Notice of Modification

Section 75W of the *Environmental Planning and Assessment Act 1979*

The project approval (08_0101) granted by the Minister for Planning on 26 November 2010 for the Integra Underground Project.

Figure 4: Approved Middle Liddell Seam - Longwall Panels (330 m width for Longwalls 15 – 19)

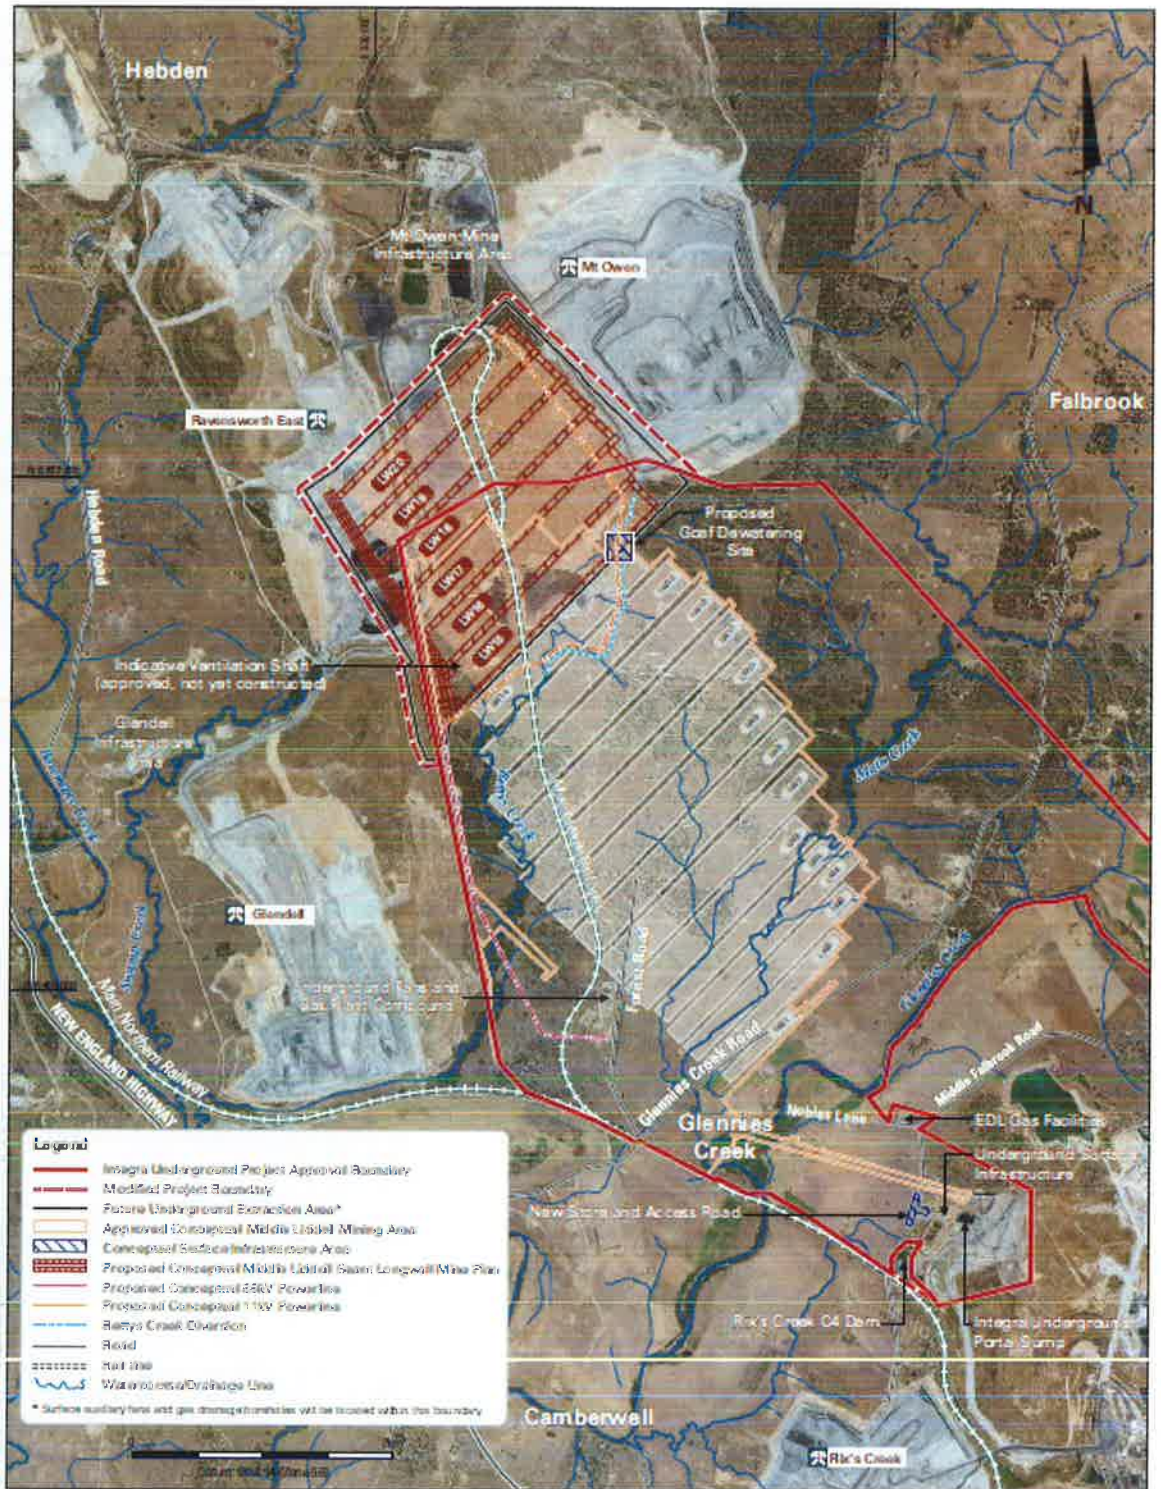
11. Delete Figure 2 in Appendix 3.
12. In Appendix 3, following Figure 3, insert the following:
